BACK RIVER PROJECT
Responses to 2018 Annual Report Comments

July 19, 2019

Responses to 2018 Annual Report Comments

PROJECT NO.	FIGURE	REV.
18114181	1	A

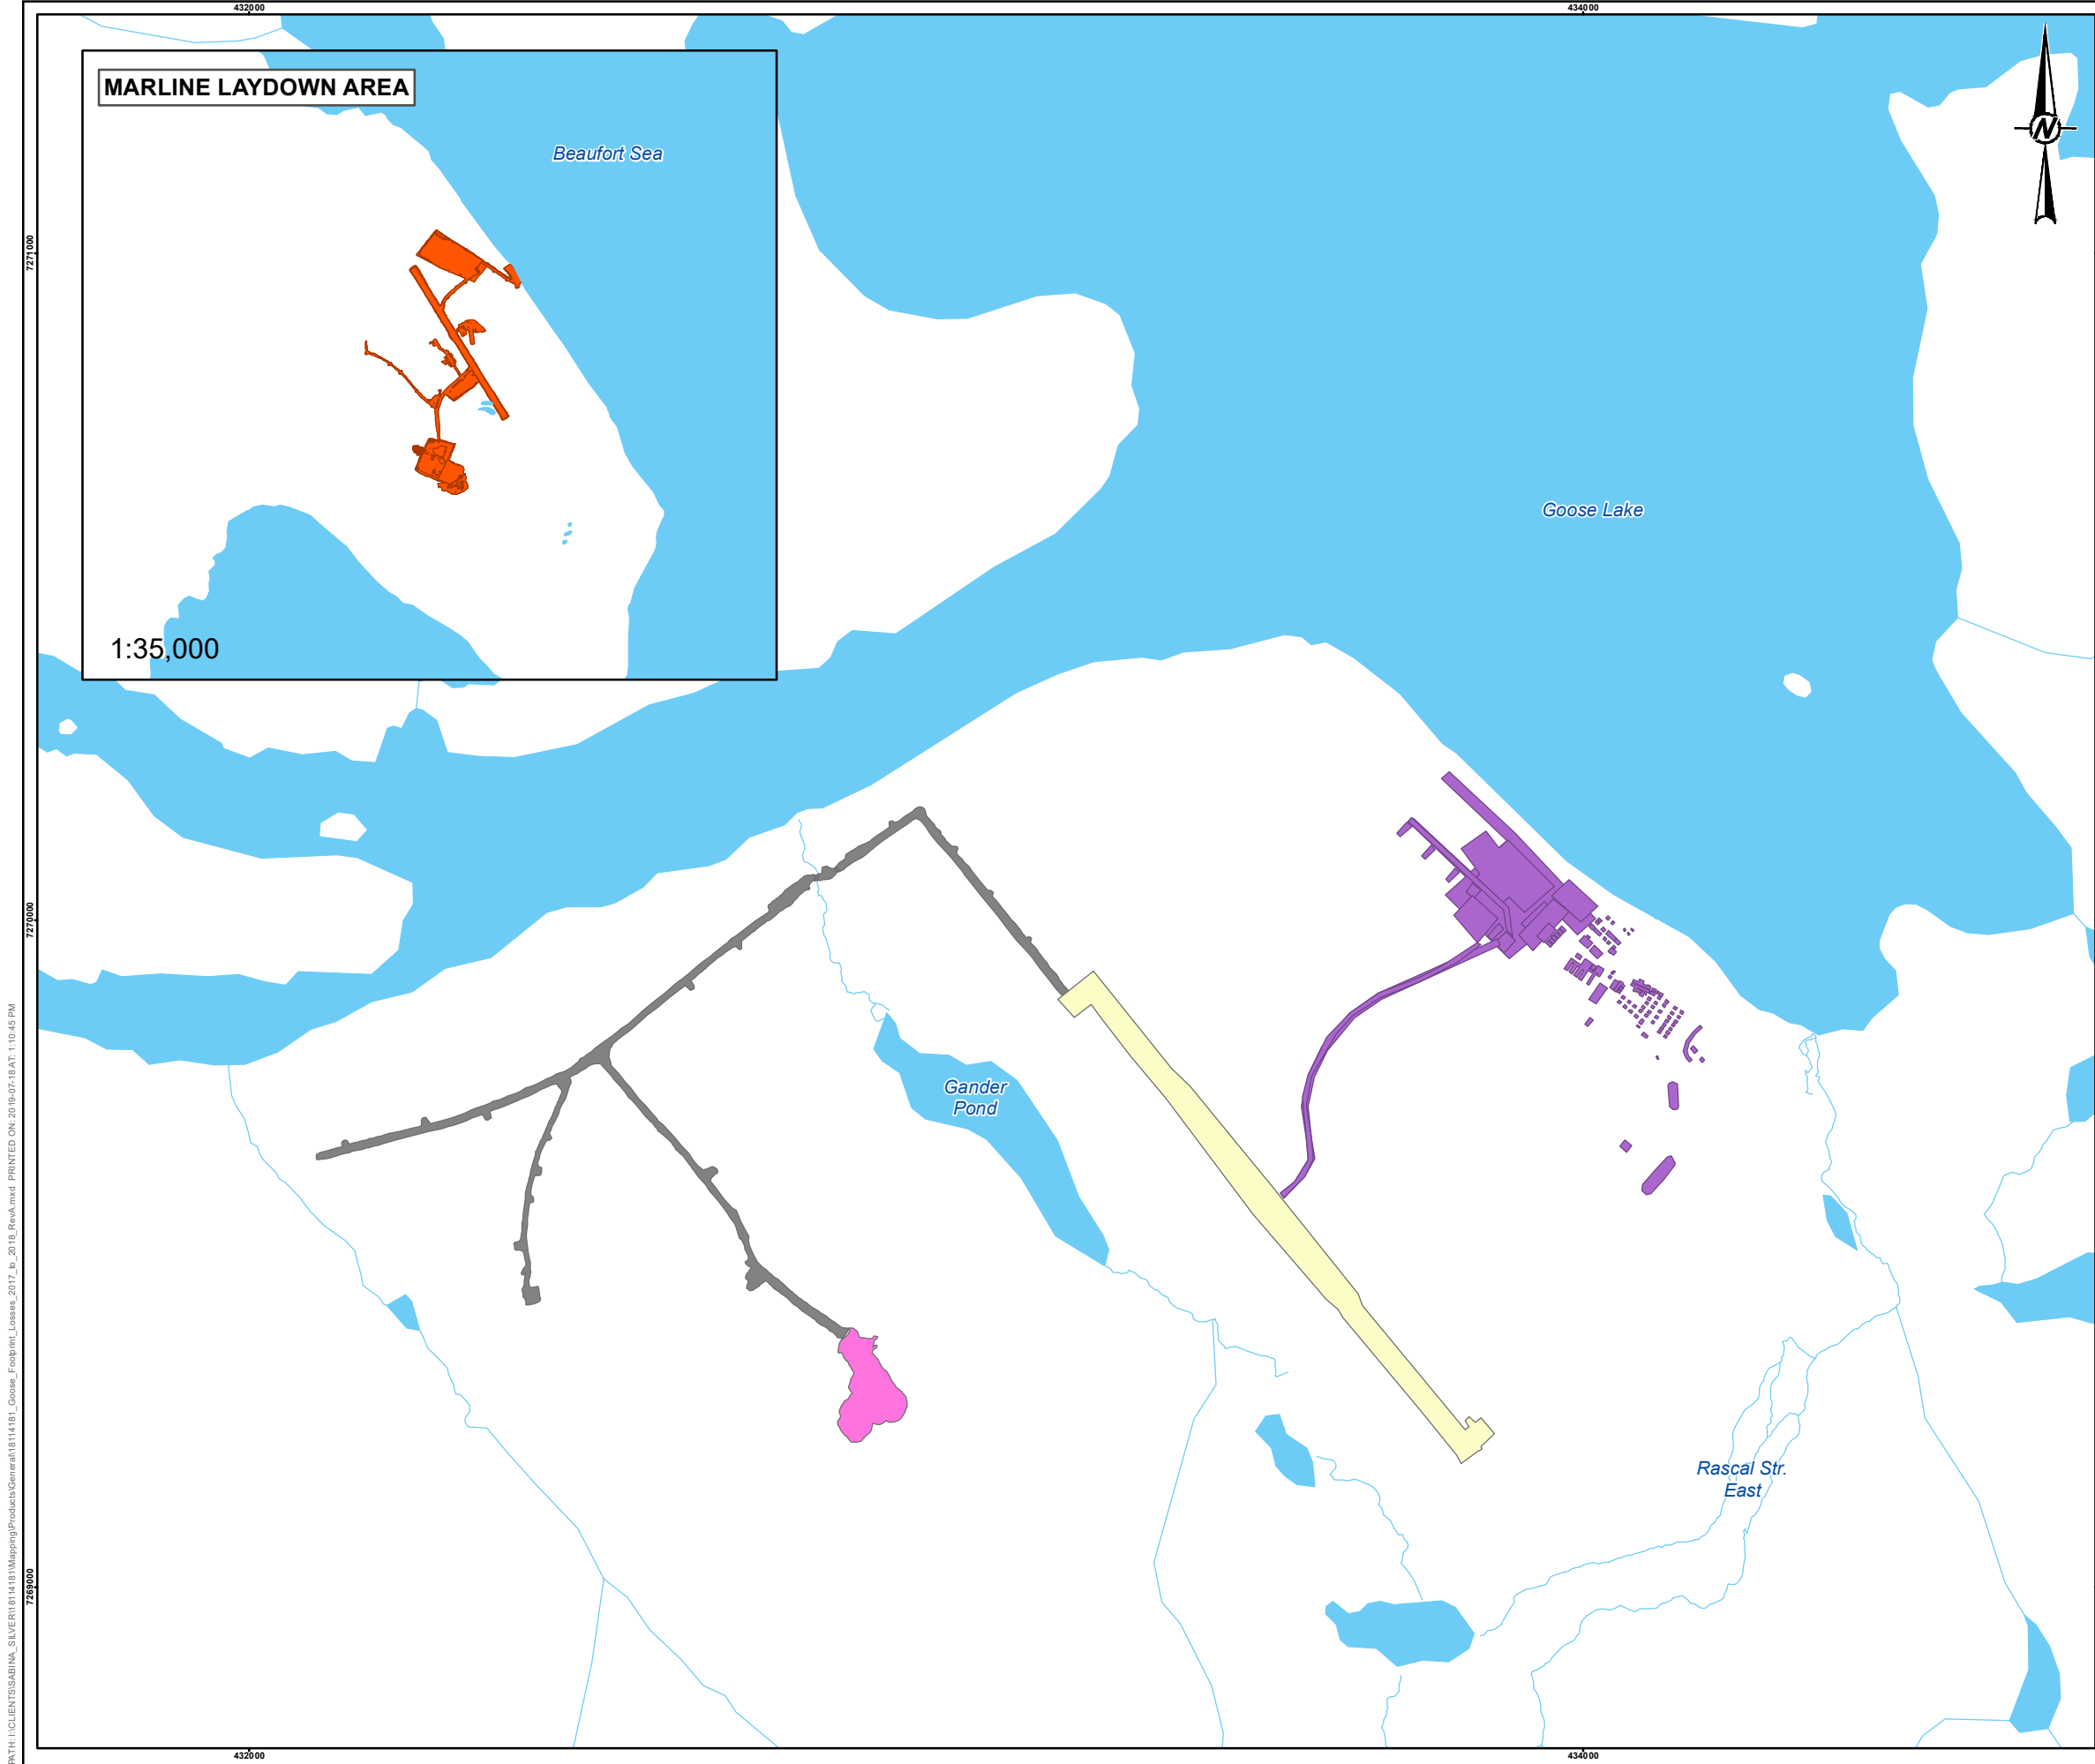
While the proponent has provided a baseline vegetation sampling report as described in the “Vegetation Monitoring Program” (Golder 2018), there was no description of the current project footprint or the change in vegetation/ footprint due to the pre-construction activities completed so far including: earthworks and initial commissioning of the MLA, two cargo sealifts, commenced earthworks at goose site including quarry expansion, and initial road and bridge construction.

Please provide the current footprint estimate and clarify the area of lost vegetation associated with Project activities.

Figure 1 (below) is a graphic representation displaying 2017 and 2018 footprints for the Goose Property and MLA. The MLA was not constructed in 2017.

Ecosystem/vegetation losses associated with current footprint for the Goose Property and the MLA are presented below in Table 1. To date, 11.7 ha (<0.01% of the LSA) has been affected due to Goose Property development, of which 9.3 ha (<0.01% of the LSA) are vegetated ecosystems. Development activities associated with the MLA property has affected 9.6 ha (<0.1% of the LSA), largely limited (9.6 ha) to vegetated ecosystems.
